Asunto: Ref.: Vertedero de Chiquita Canyon - Presentación de Temperaturas de TMP

Subject: RE: Chiquita Canyon Landfill – TMP Temperature Submittal

Solid Waste Borehole Maximum Temperature Profiles Over 6 Weeks for 2/12/2026 to 3/25/2026

07224053.00 | March 26, 2026

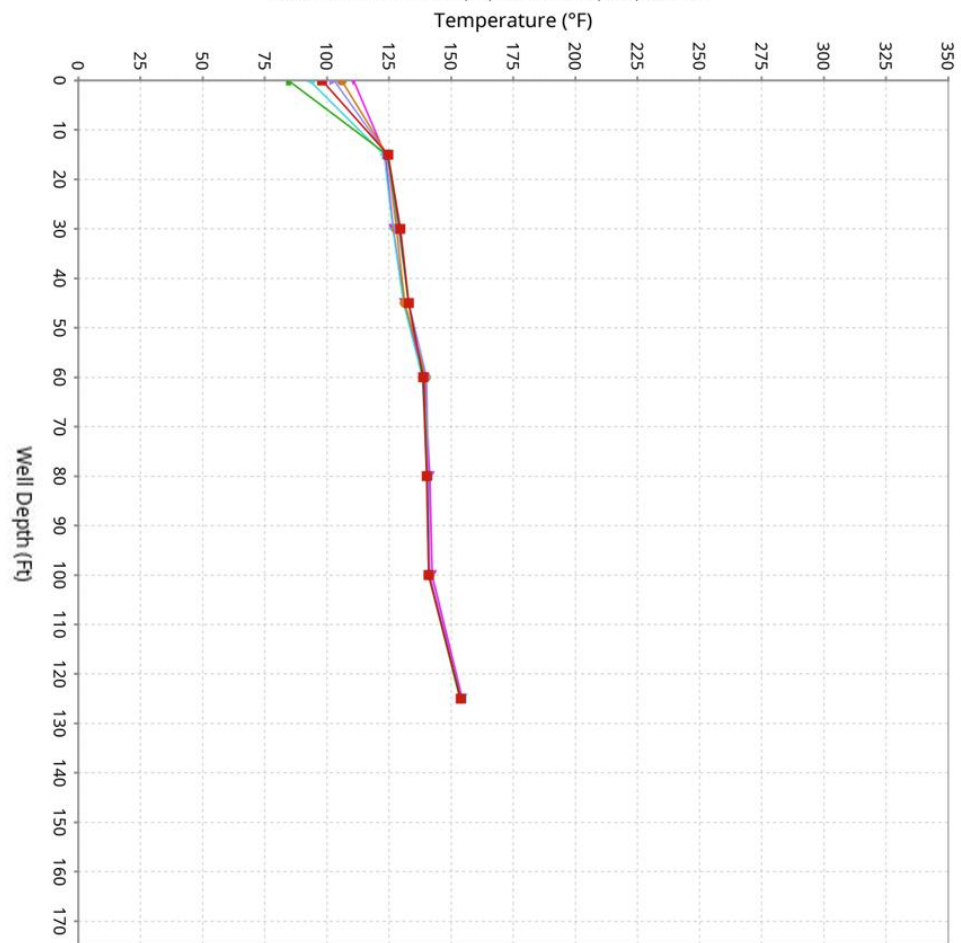
Desviación de las Sondas
de Temperatura

TP-1	Ninguna
TP-2	Ninguna
TP-3	Ninguna
TP-4	Ninguna
TP-5	Ninguna
TP-6	Ninguna
TP-7	Ninguna
TP-8	Ninguna
TP-9	a 80 pies
TP-10	a 80 pies
TP-11	a 80 pies
TP-12	a 80 pies
TP-13	a 75 pies
TP-14	a 100 pies
TP-15	a 45 pies
TP-16	a 60 pies
TP-17	a 80 pies
TP-18	a 15 pies
TP-19	a 100 pies
TP-20	a 15 pies
TP-21	a 85 pies
TP-22	Ninguna
TP-23	a 30 pies
TP-24	a 210 pies
TP-25	a 90 pies
TP-26	a 100 pies
TP-27	a 100 pies
TP-28	a 120 pies

TP-29 a 160 pies
TP-30 a 130 pies
TP-31 a 180 pies

TP-32 a 130 pies
TP-33 a 15 pies
TP-34 a 90 pies
TP-35 a 105 pies
TP-36 a 160 pies
TP-37 a 130 pies
TP-38 a 160 pies
TP-39 a 105 pies
TP-40 a 160 pies

Vertical Temperature Profiles from Temperature Probes at Chiquita Landfill for TP-10

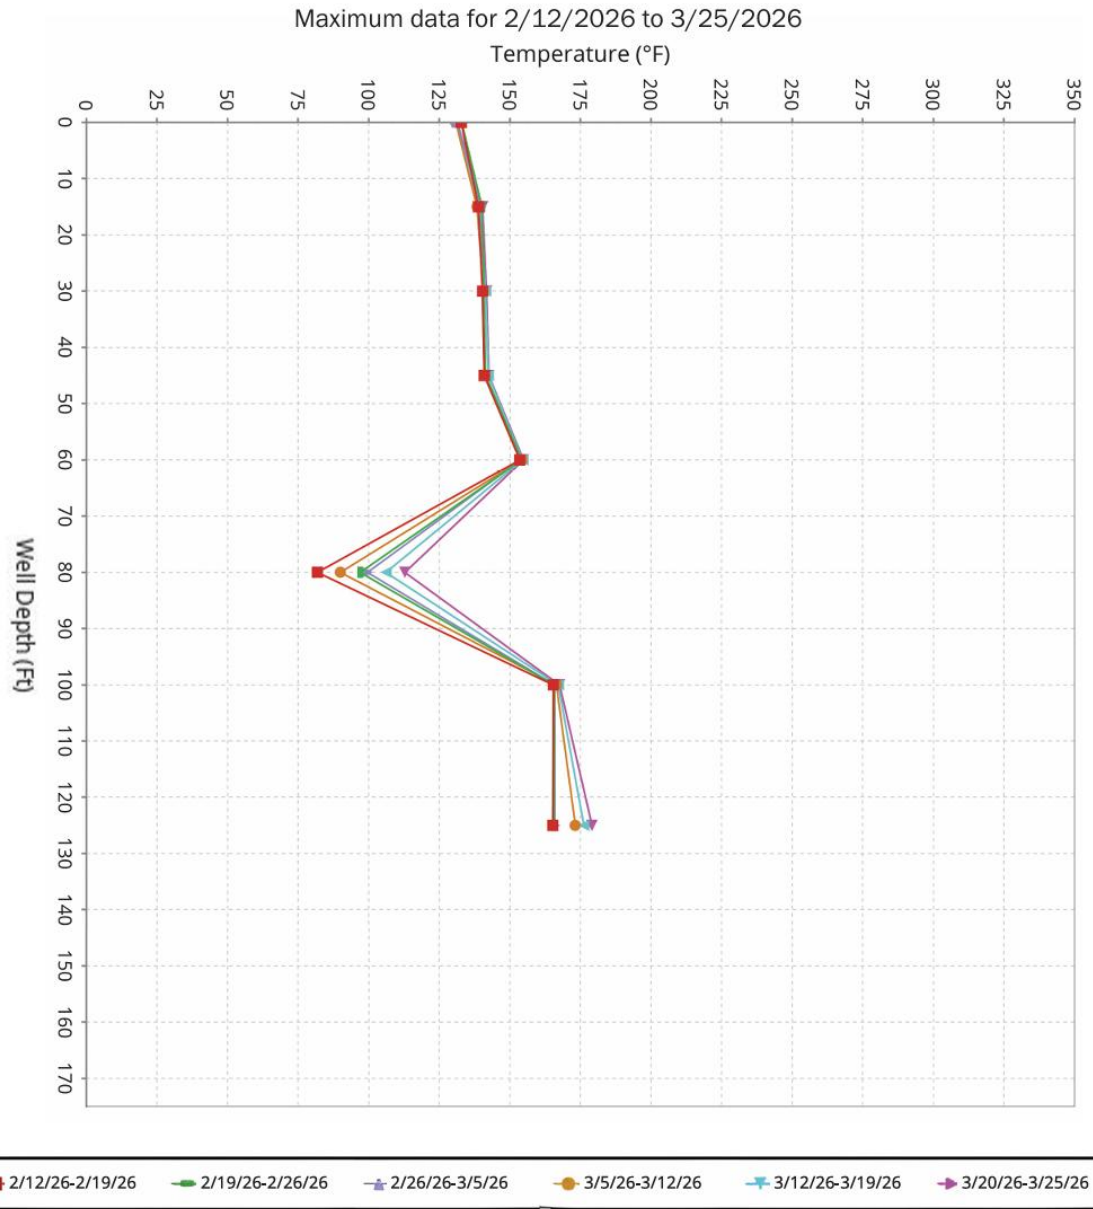
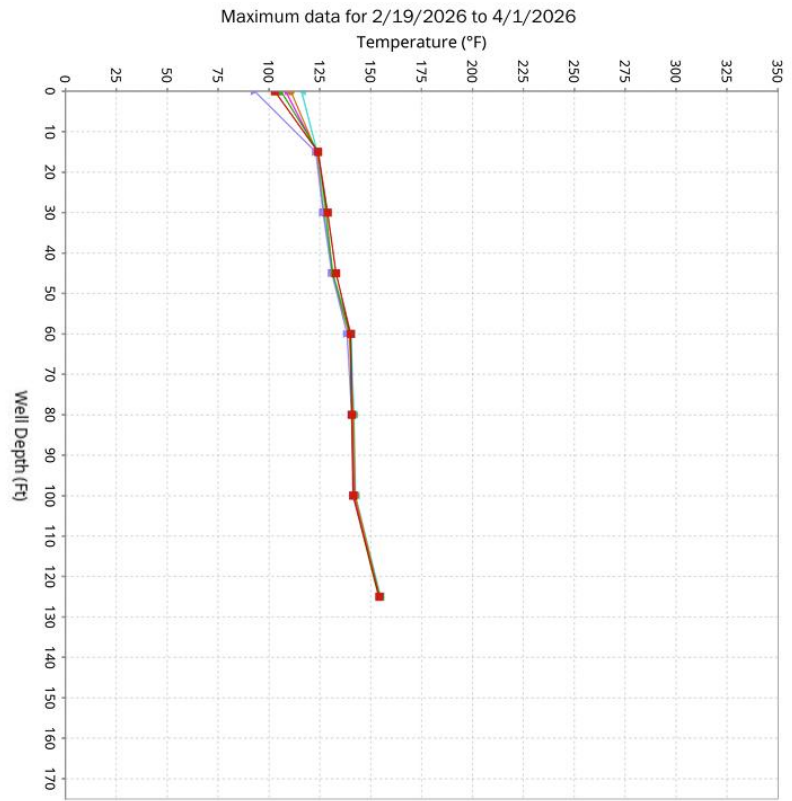
Me preocupa que ni usted ni SCS Engineers hayan tomado conocimiento de las importantes oscilaciones en las temperaturas en su última presentación de TMP, con fecha 26 de marzo de 2026. Dada la magnitud de las oscilaciones de temperatura (25 °F a 40 °F) en varias profundidades y TP durante seis semanas, asumo que su presentación de TMP gráfico utilizó datos crudos incorrectos. La semana anterior, el 18 de marzo y recientemente el 1 de abril de 2026 no exhibieron el problema. Los siguientes TMs tienen problemas de temperatura. Observe los detalles en el archivo Excel adjunto.

Como ejemplo. Observando TMP 10

18 de marzo de 2026 (Sin oscilaciones de temperatura importantes a 80 pies)

These temperature deviations are significant. Please evaluate and resubmit the March 26, 2026, TMP Weekly Report if in error. If not, please contact the LEA as soon as possible and schedule a meeting to discuss the rapid change in temperatures.

Los datos crudos incluidos en la presentación del 26 de marzo de 2026 son correctos y las oscilaciones en las temperaturas que aparecen en los gráficos presentadas el 26 de marzo de 2026, son incorrectas. Durante la creación automatizada de estos gráficos el 26 de marzo de 2026, ocurrió un error en la red que hizo que los gráficos no se basaran en los datos crudos presentados. Se adjuntan los gráficos de las temperaturas correctas para este período. Por favor, dígnanos si tienen alguna otra pregunta.
